# DRAINAGE LETTER

## **ROLLING THUNDER BUSINESS PARK FILLING NO. 2**

A REPLAT OF LOTS 2 AND 3, ROLLING THUNDER BUSINESS PARK  
County File No.s: SF 209 and PRP2010

# Drainage Report\_v2\_redlines.pdf Markup Summary

# National Flood Hazard Layer FIRMette

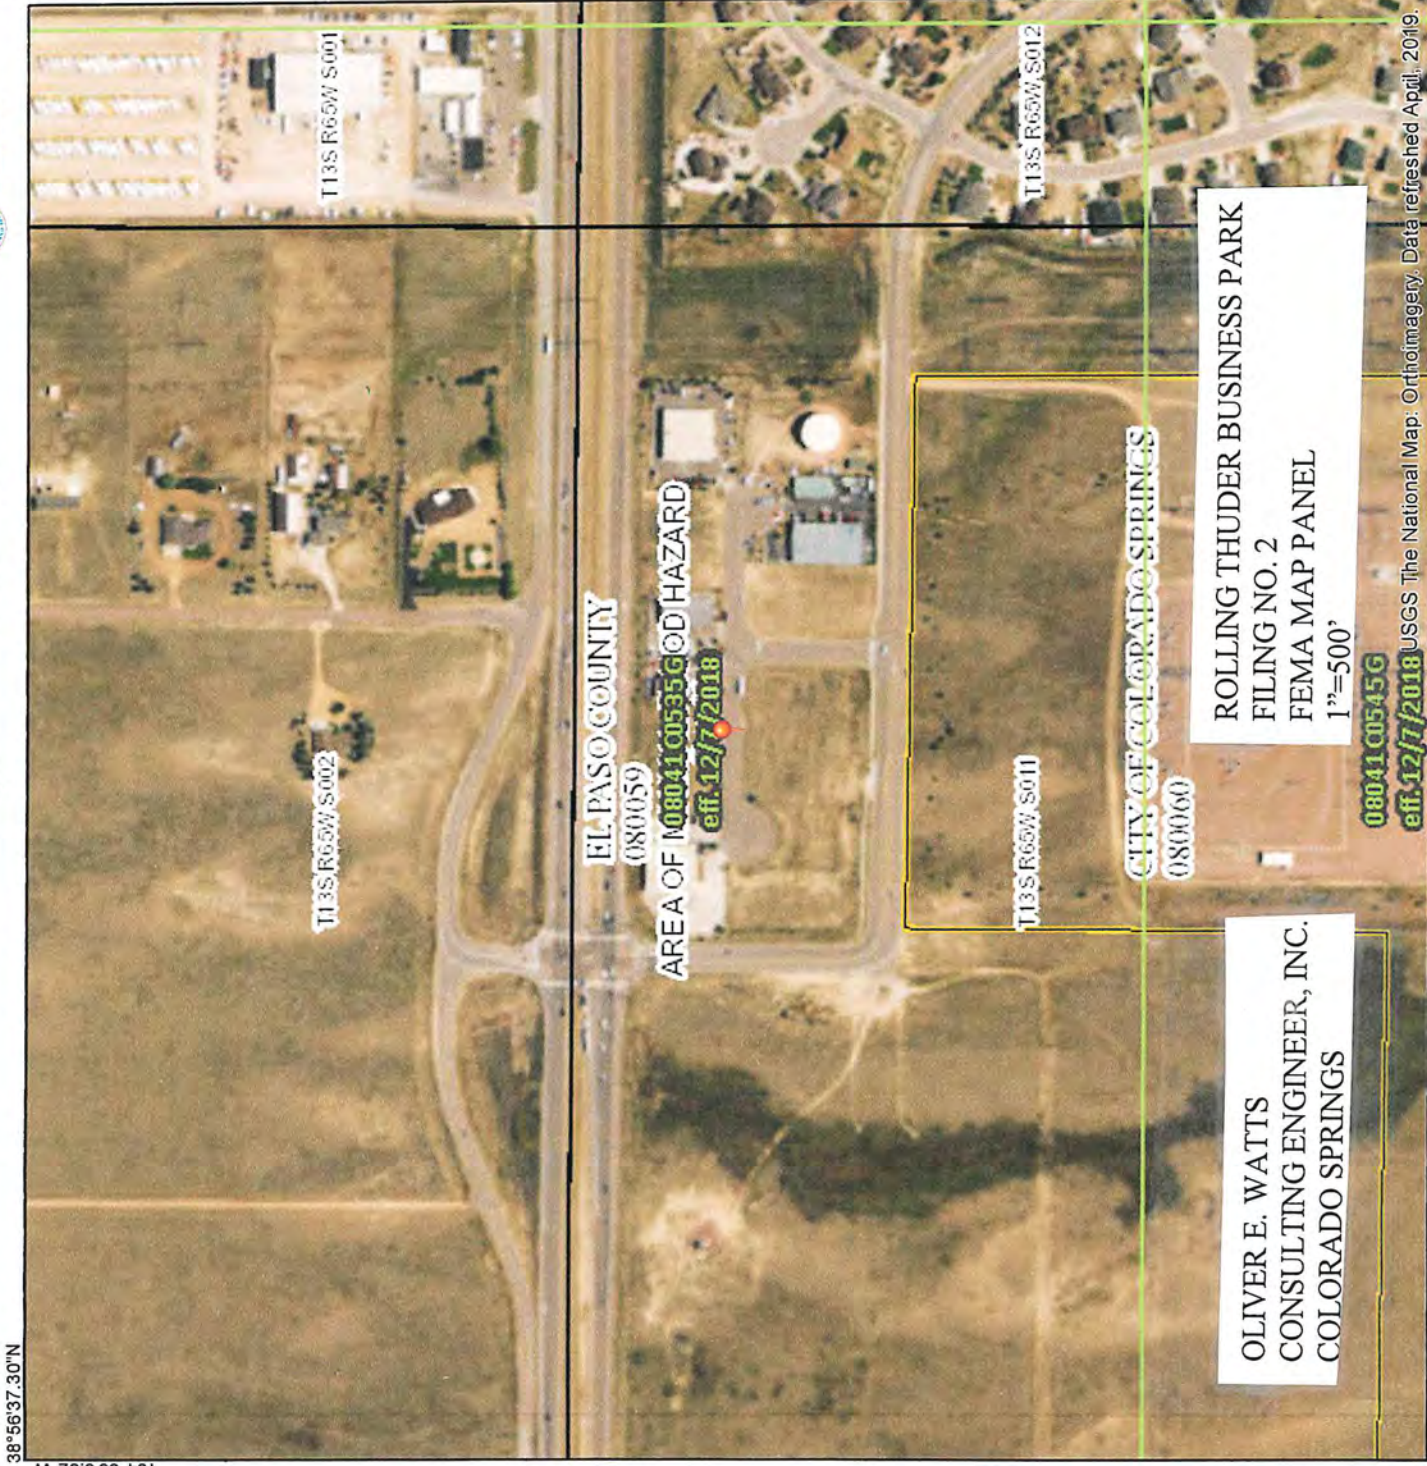
The attached FEMA FIRM map indicates the panel no. as: 08041C0535G  
Please revise

**ROLLING THUNDER BUSINESS PARK - FDR - DEVELOPED CONDITIONS**  
**(RATIONAL METHOD Q=CIA)**

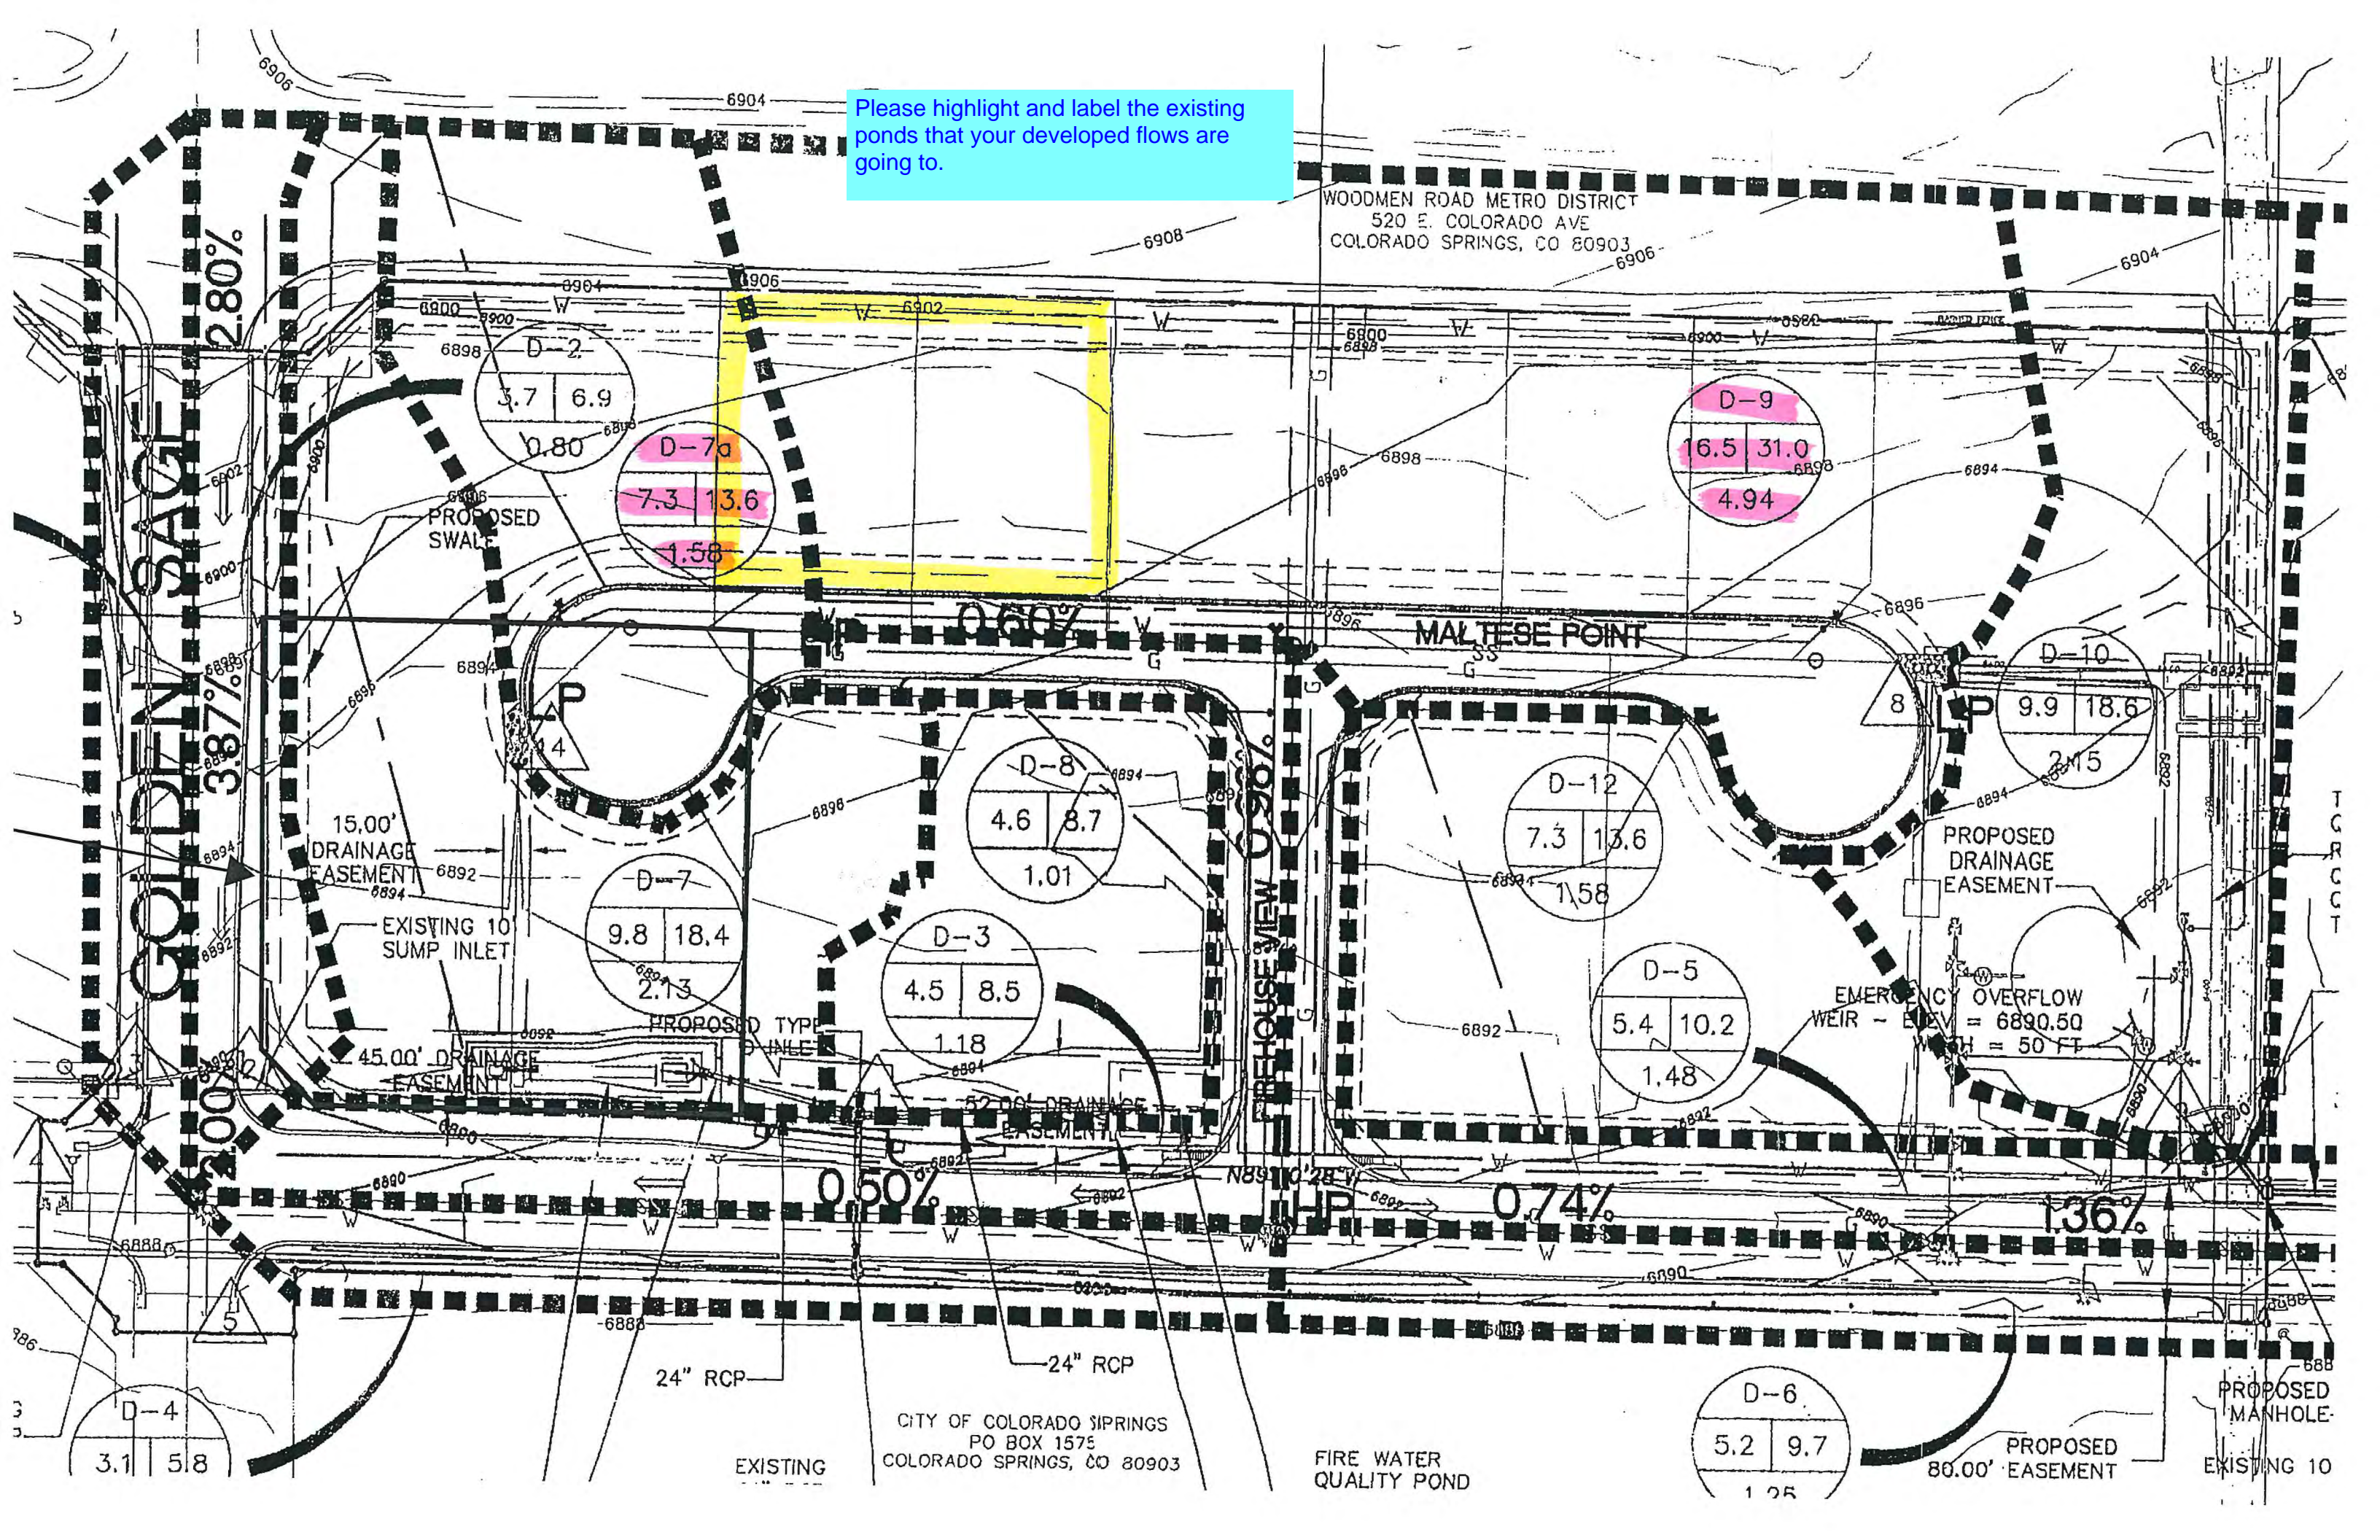
Please highlight and label the existing ponds that your developed flows are going to.

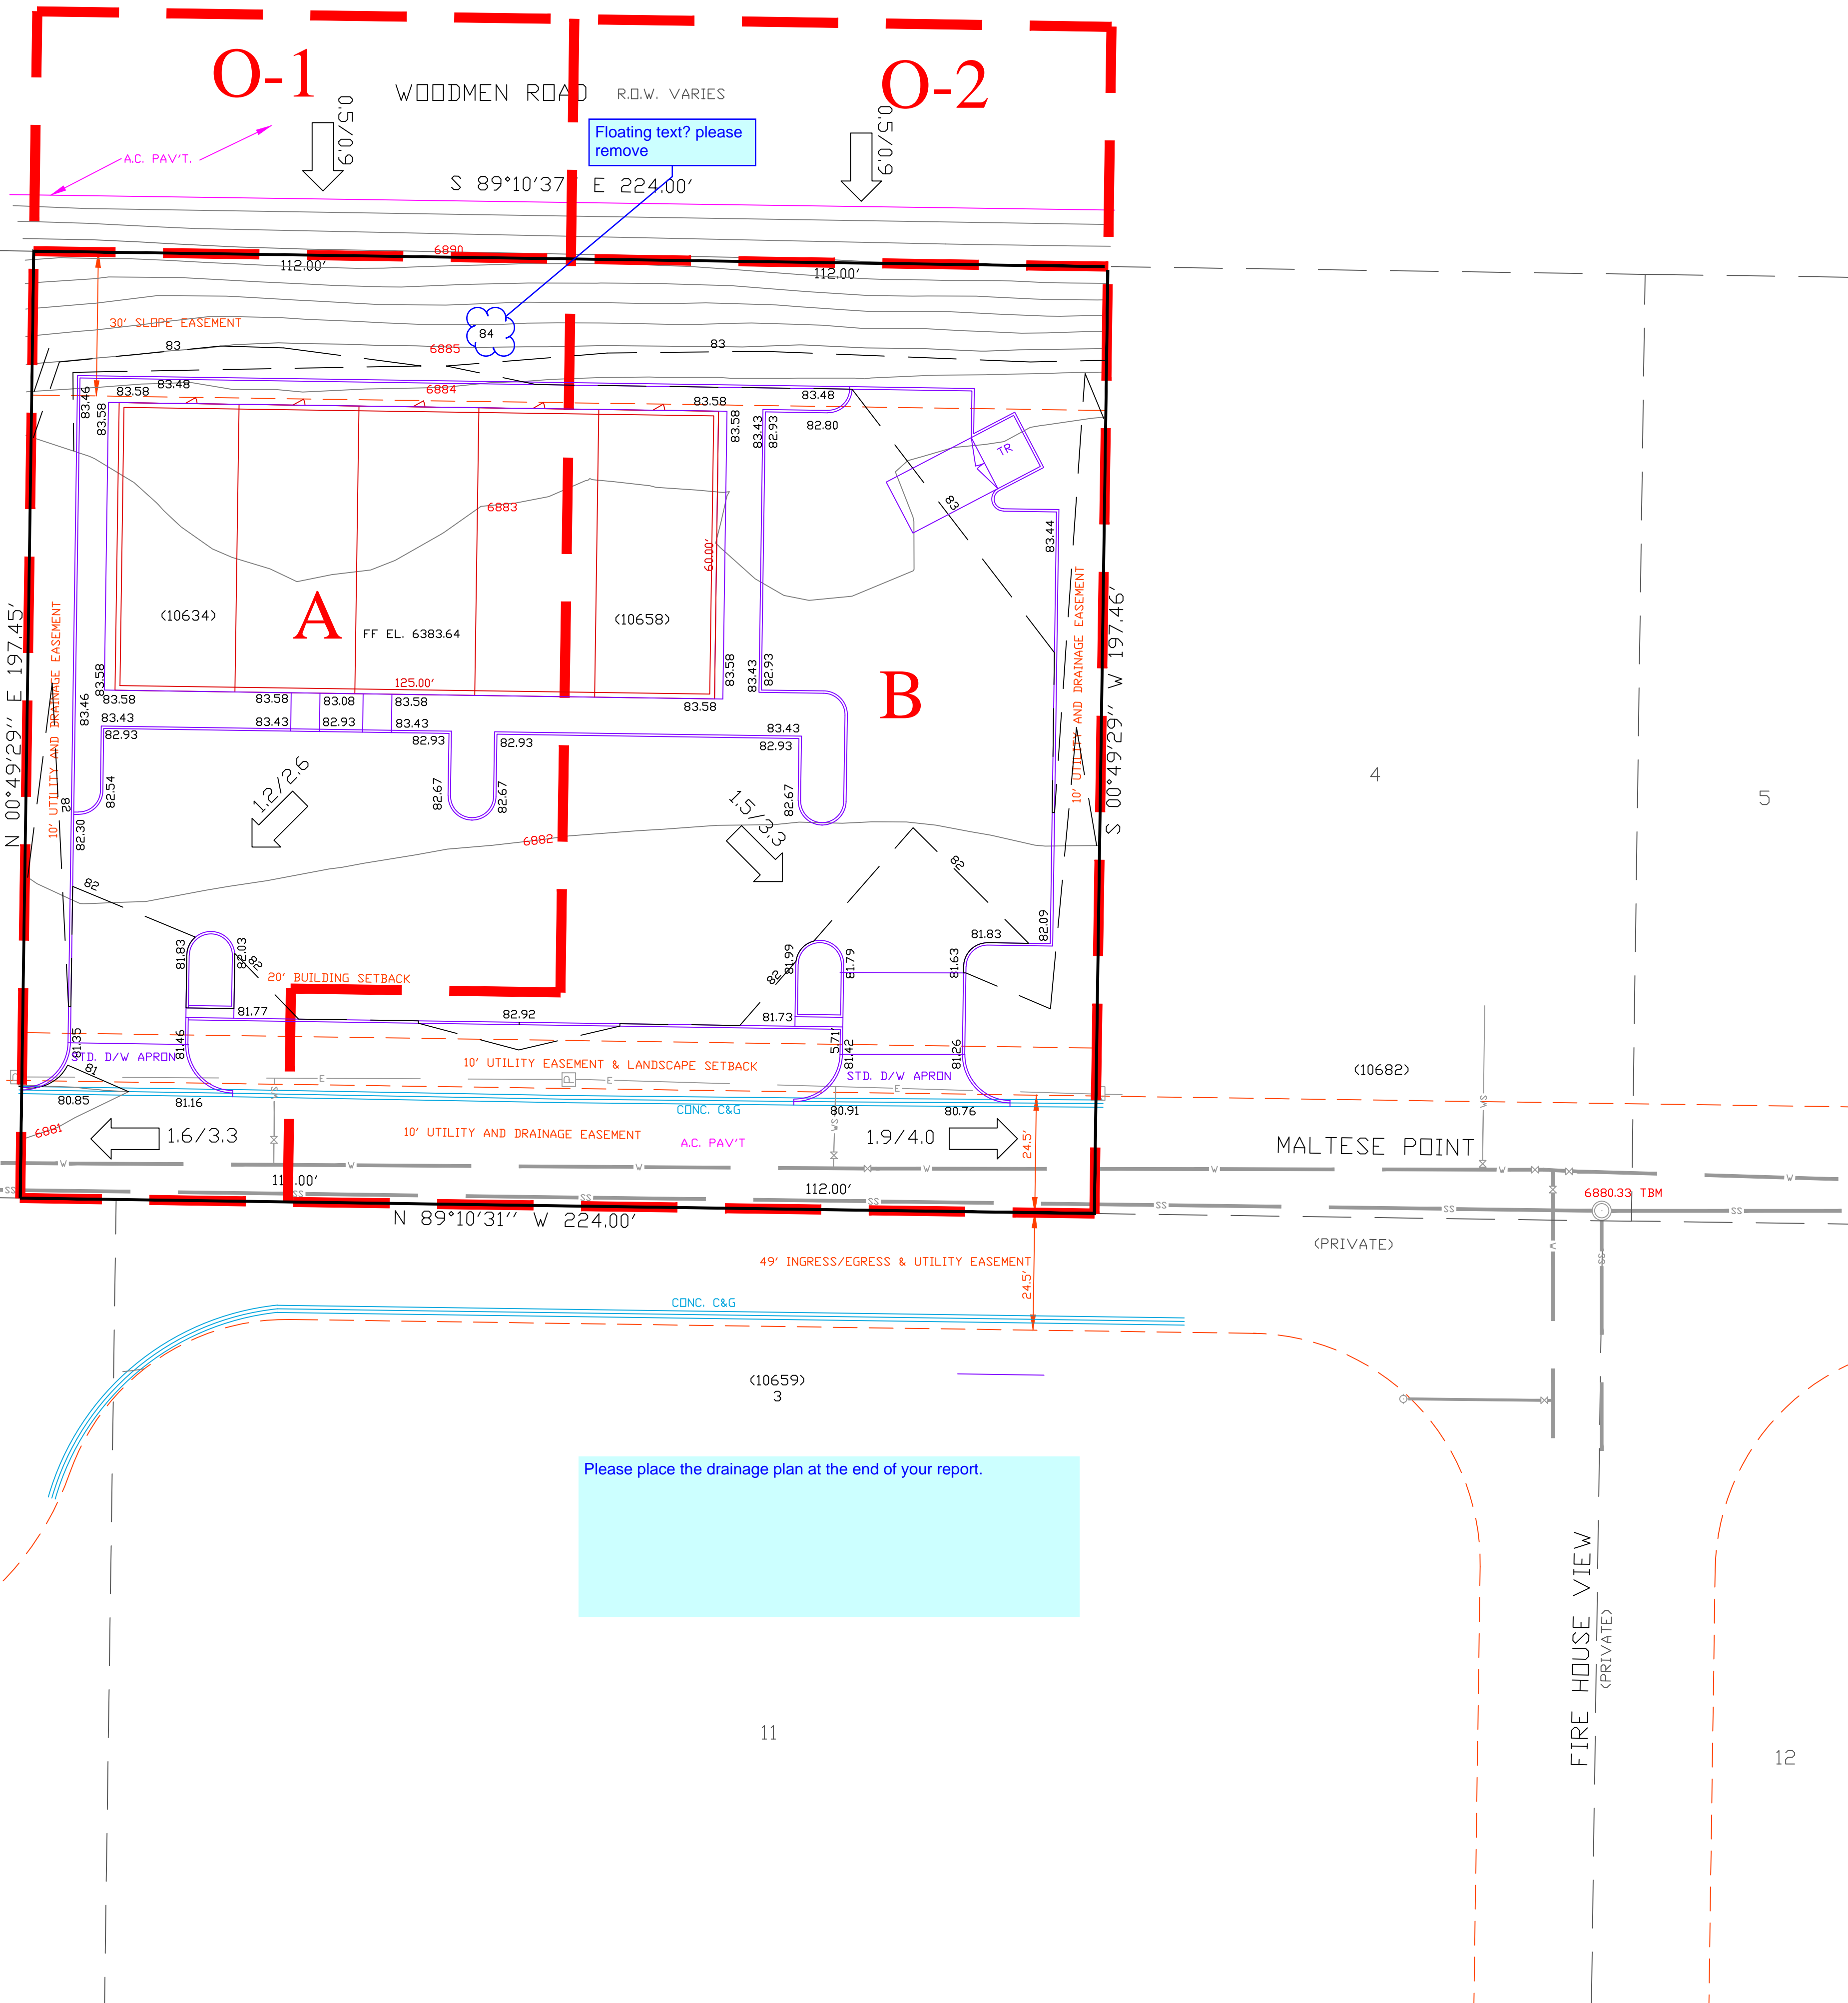
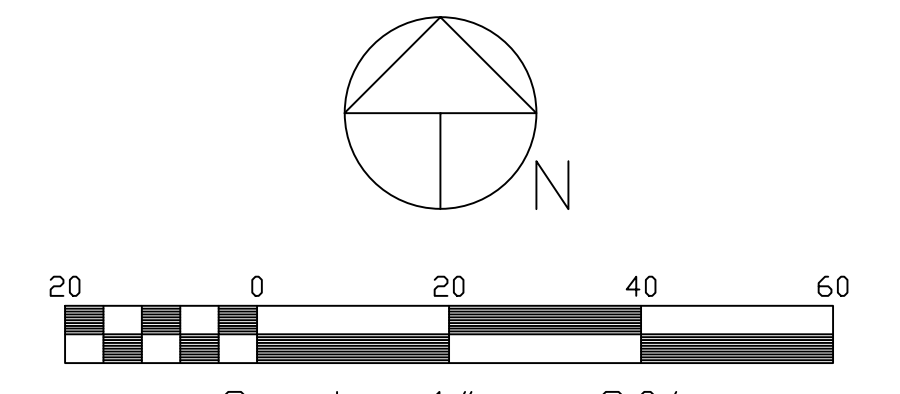
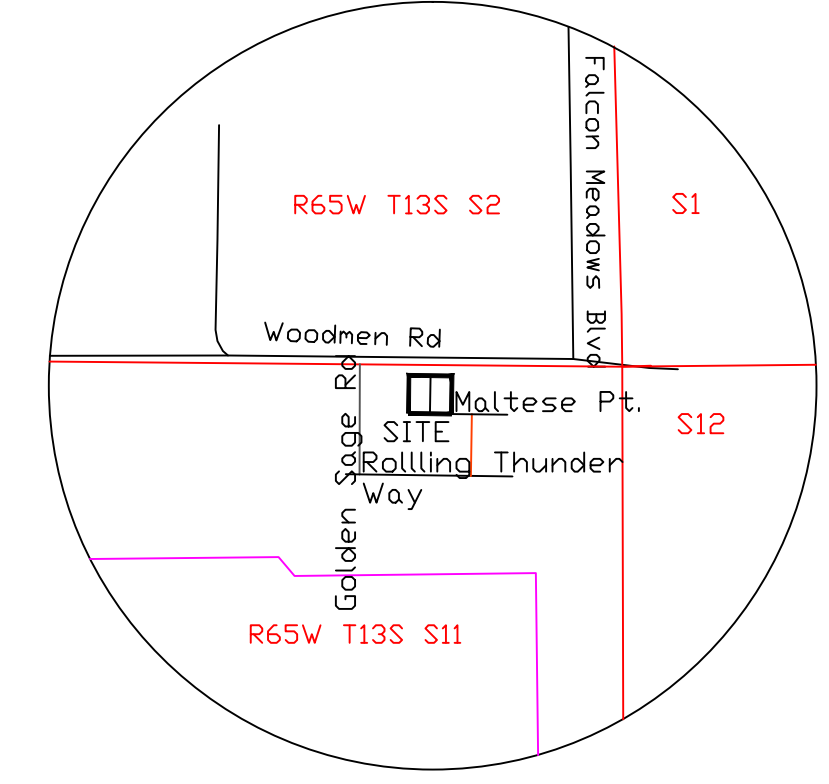
Please place the drainage plan at the end of your report.
